FORT BEND COUNTY CHANGE ORDER

PROJECT:
Fort Bend County South Post Oak
Baseball Fields Upgrade
5675 Hobby Road, Houston, TX 77053

CHANGE ORDER NUMBER 1
DATE 3/21/2024
PROJECT NUMBER B23-012
BID NO B23-012
CONTRACT DATE 2/14/2023
FBC PURCHASE ORDER NO 223051

Change Order #1

REFERENCE: Sportsplex Main Communication Extra Conduit and Innerduct

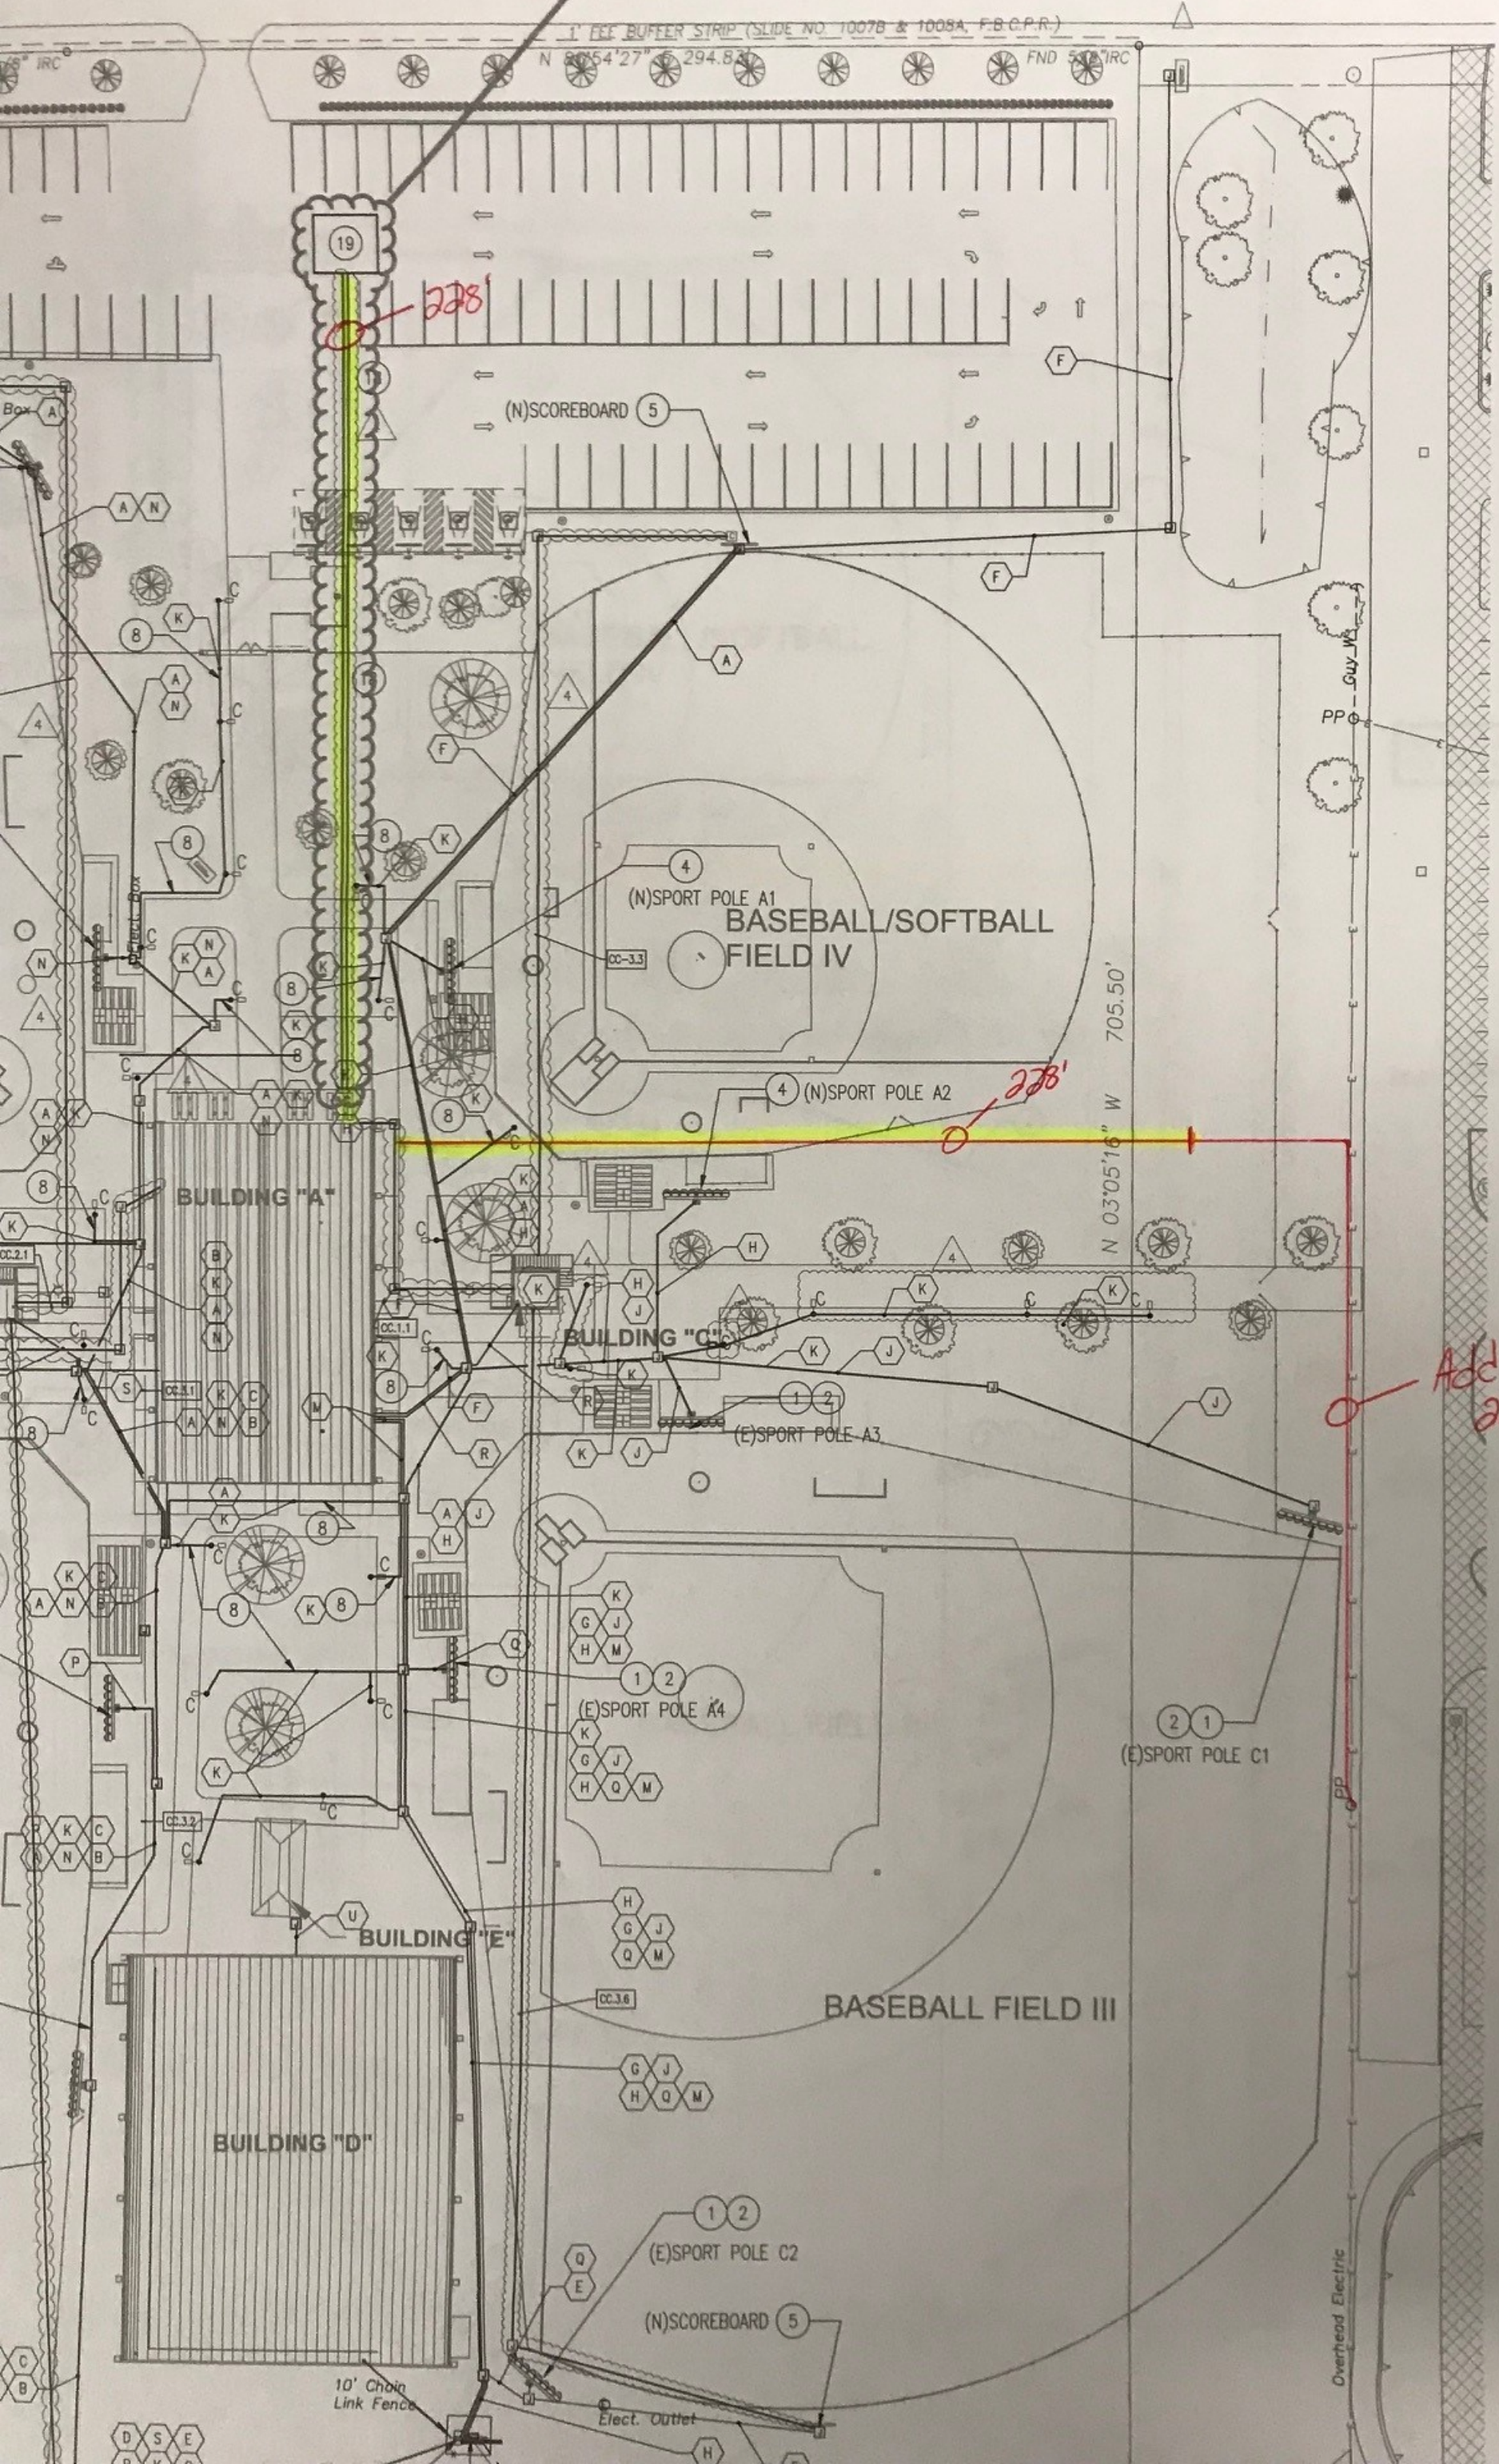
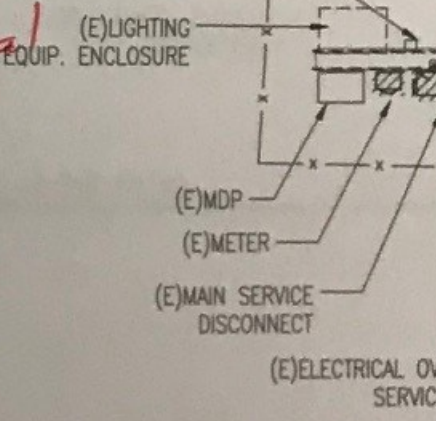
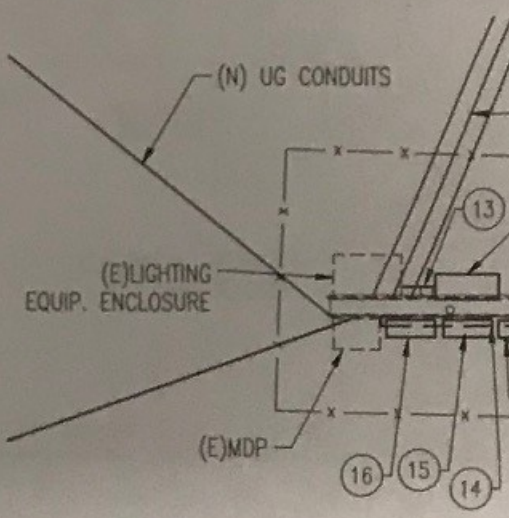
Relocate Main data/ comm conduit from parking lot to new location (250' further than original location) per email drawing

Additional
225'
